## HISTORIC AND DESIGN REVIEW COMMISSION

**HDRC CASE NO:** 2018-626  
**ADDRESS:** 9211 S PRESA ST  
9159 S PRESA ST  
**LEGAL DESCRIPTION:** NCB 10917 P-106 1.494 AC NCB 10918 P-107 .506 AC  
NCB 10918 BLK LOT P-106  
**ZONING:** MF-33, H  
**CITY COUNCIL DIST.:** 3  
**DISTRICT:** Mission Historic District  
**APPLICANT:** Stedman Grigsby and David Lefton/The Brownstone Group  
**OWNER:** San Juan Mission Villas Ltd  
**TYPE OF WORK:** Final Approval for New Development  
**APPLICATION RECEIVED:** December 12, 2018  
**60-DAY REVIEW:** February 10, 2019  
**REQUEST:**

The applicant is requesting conceptual approval to construct a multi-family residential development to feature 102 residential units. The proposed development is to feature two, three story residential structures as well as a one story clubhouse.

**Historic and Design Review Commission  
Design Review Committee  
Report & Recommendation**

SAN JUAN MISSION VILLAS-  
Site plan overlay

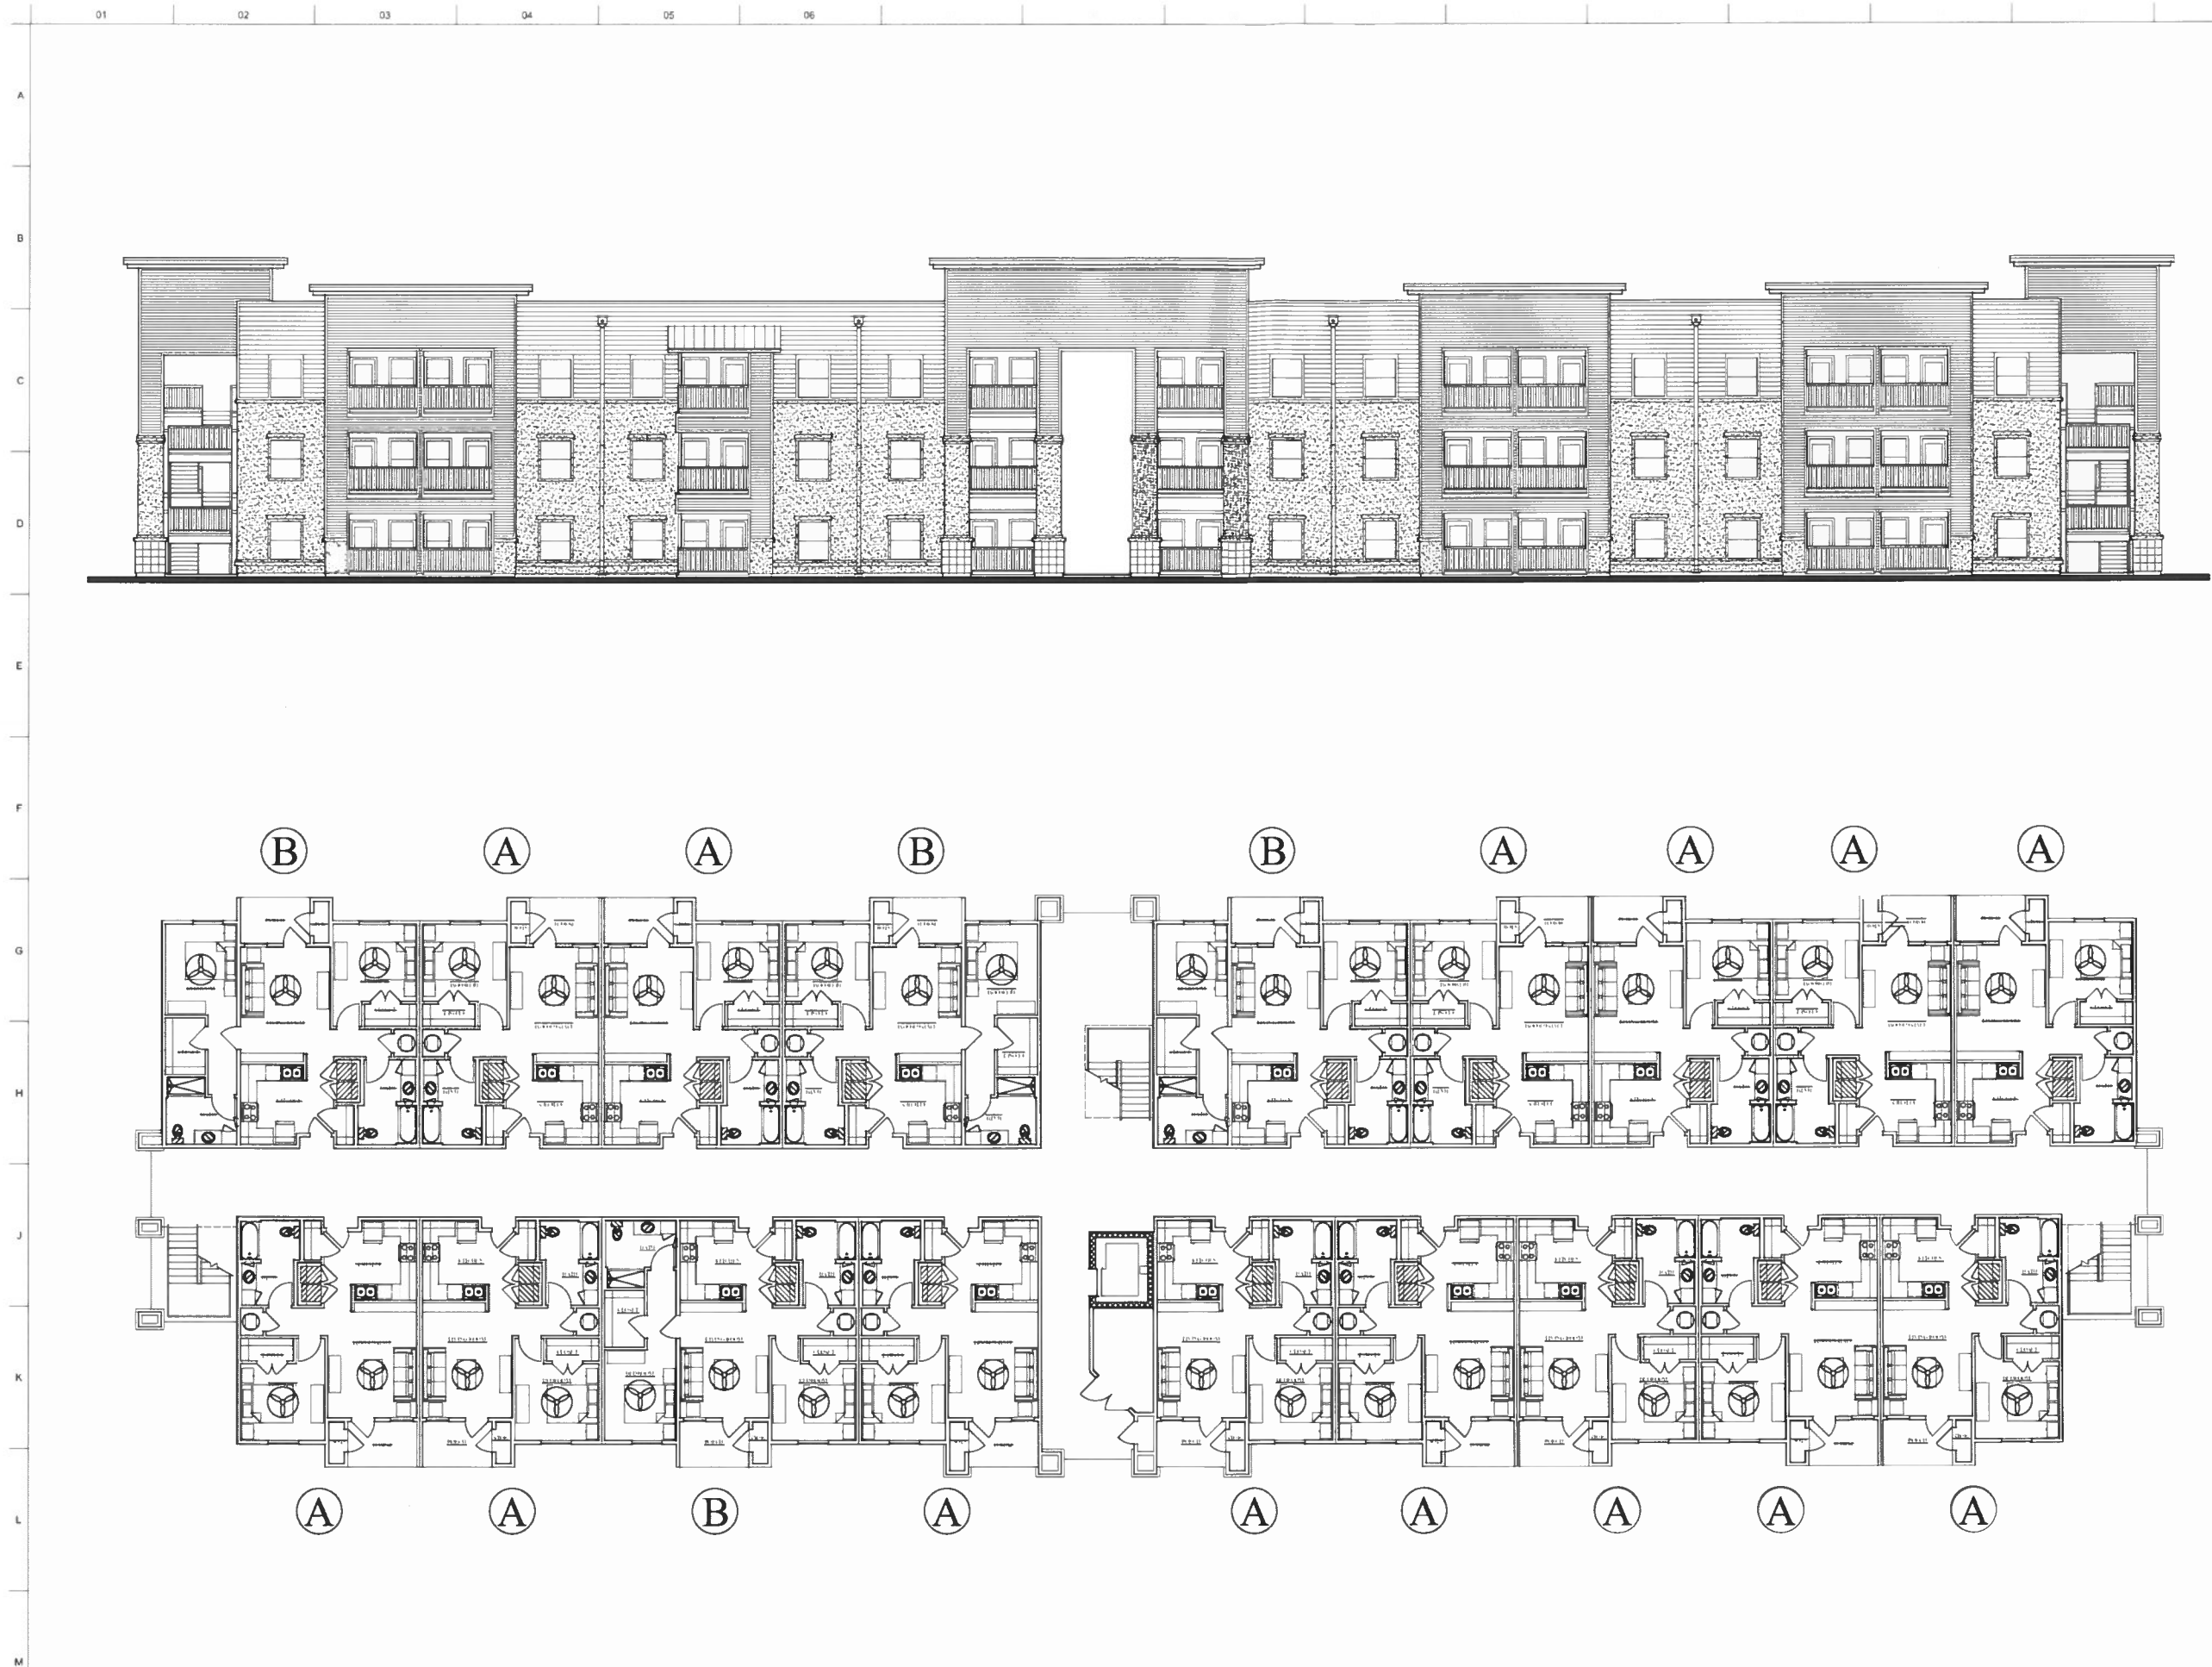
- g. VEHICULAR ACCESS – The Mission Design Manual notes that driveway widths should not exceed twenty-four (24) feet in width. The applicant has not specified a width at this time, but per the site plan, the width appears greater than 24 feet. The applicant has noted that the existing, landscaping island will be increased to reduce the perceived width of the entrance drives.

**COMMENTS/CONCERNS:** JM: OVERVIEW OF PROPOSAL, UPDATES TO DESIGN  
VS ORIGINAL DESIGN, OVERVIEW OF STAFF'S PREVIOUS COMMENTS AND  
HOW THEY'VE BEEN ADDRESSED BY DESIGN TEAM / DISCUSSION WITH  
COMMITTEE. EG: A VERY MUCH NEEDED DEVELOPMENT - FOOTPRINT  
OKAY. JM: WIDTH OF ISLAND BETWEEN ENTRANCE/EXIT WILL BE INCREASED  
TO BE LESS IMPACTFUL TO SITE / PROVIDE LESS PAVING. JM: OVERVIEW  
OF MATERIALS. SC: UPDATED DESIGN IS APPROPRIATE. MG: PROVIDE  
SLIGHTLY MORE CONTEXT IN SITE AERIAL.

**1 BUILDING TYPE I - OVERALL BUILDING PLAN & STREET ELEVATION**  
 SCALE: 1" = 10'-0"

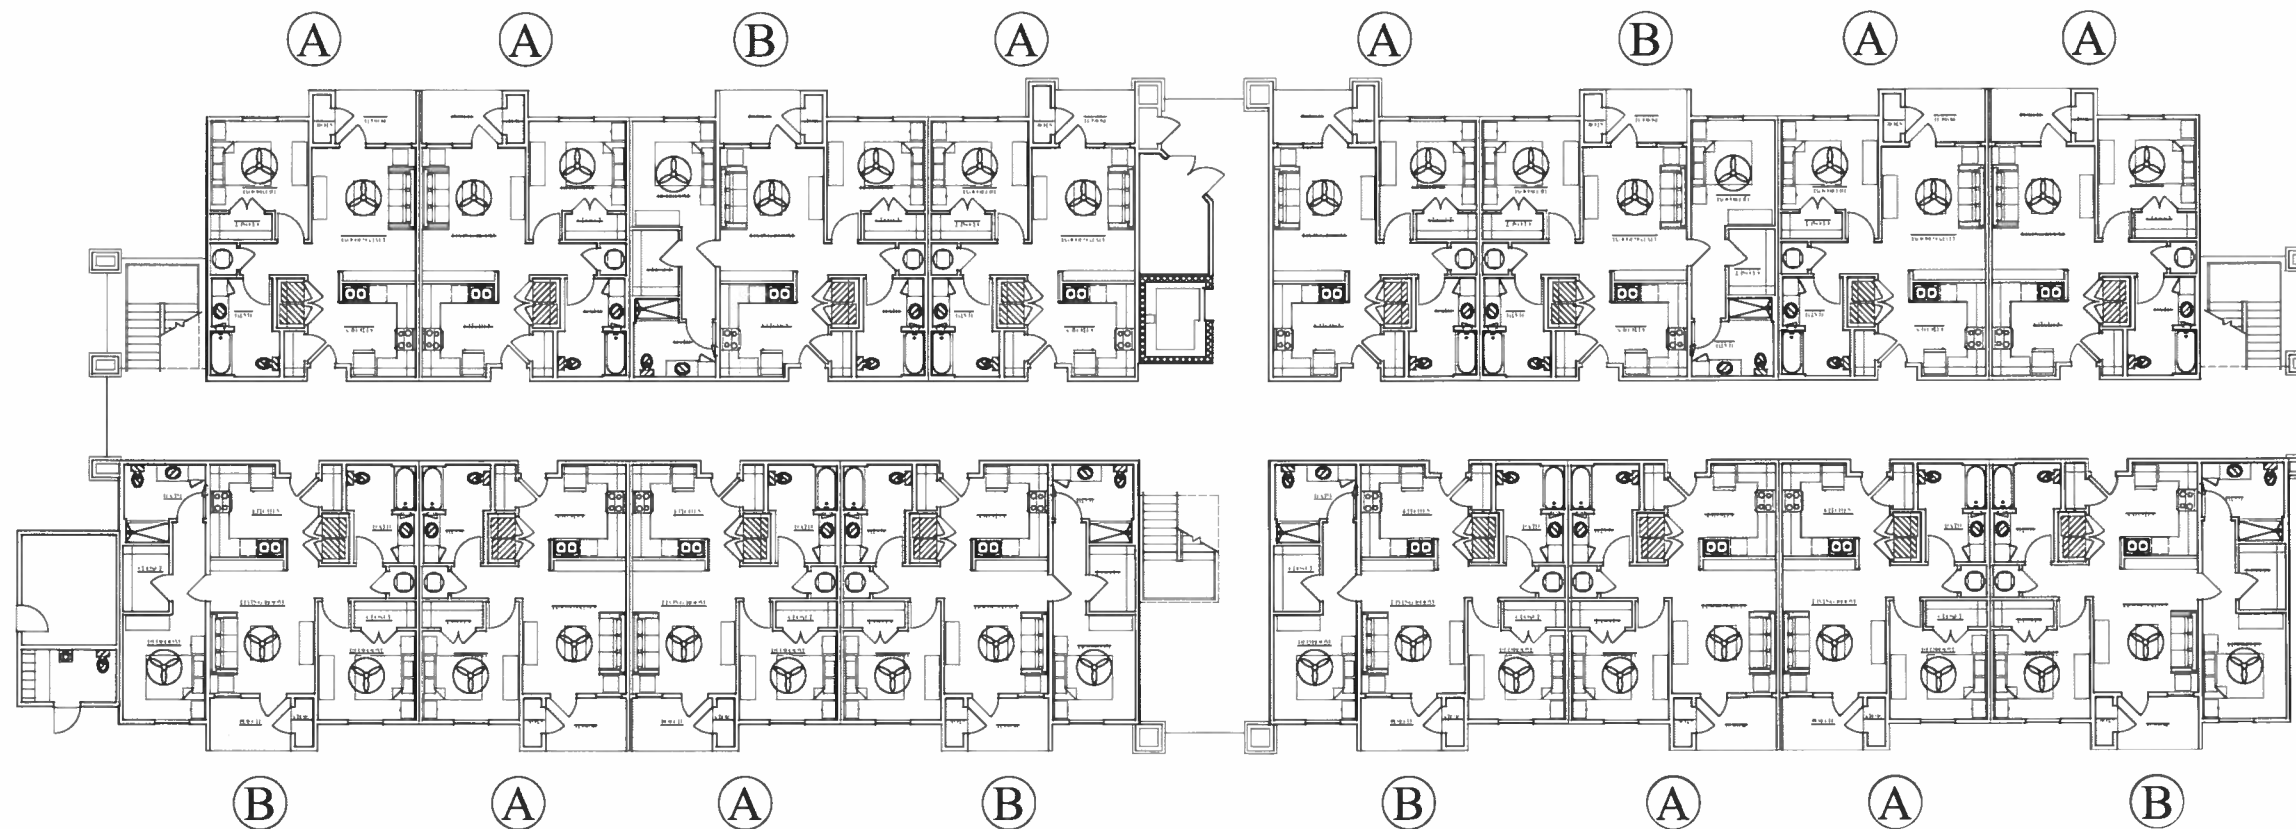
- h. FAÇADE SEPARATION – The Mission Design Manual notes that structures within the Mission Historic District should not feature façade planes that are greater than fifty (50) feet in width. The applicant has proposed various façade elements to separate the façade, including projecting masses and recessed balconies.

- k. **MATERIALS** – The applicant has proposed materials that include asphalt shingles, Hardie siding and stucco. The Manual notes that predominant façade materials should be those that are durable, high-quality, and vernacular to San Antonio such as regionally-sourced stone, wood, and stucco. Artificial or composite materials are discouraged, especially on primary facades or as a predominate exterior cladding material. Artificial or imitation stucco, such as EIFS or stucco-finish composition panels should be avoided. Applied stucco should be done by hand and feature traditional finishes. Control joints should be limited to locations where there is a change in materials or change in wall plane to create a continuous, monolithic appearance. Lastly, the use of traditional materials that are characteristic of the Missions is strongly encouraged throughout the historic district as primary materials on all building facades. For all new buildings, a minimum of 75% of the exterior facades should consist of these materials. The applicant is responsible for complying with the materials specifications. Hardie siding should feature a four (4) inch exposure and a smooth finish.

- i. That the applicant continue to develop the proposed parapet walls’ detailing including potential modifications to height to provide variations in parapet wall height that are within one foot to eighteen inches of each other.

- iii. That the applicant reduce the proposed amount of siding and develop facades that feature primarily stucco (or another type of masonry) sections. Siding should be used as a secondary material to complement a predominately
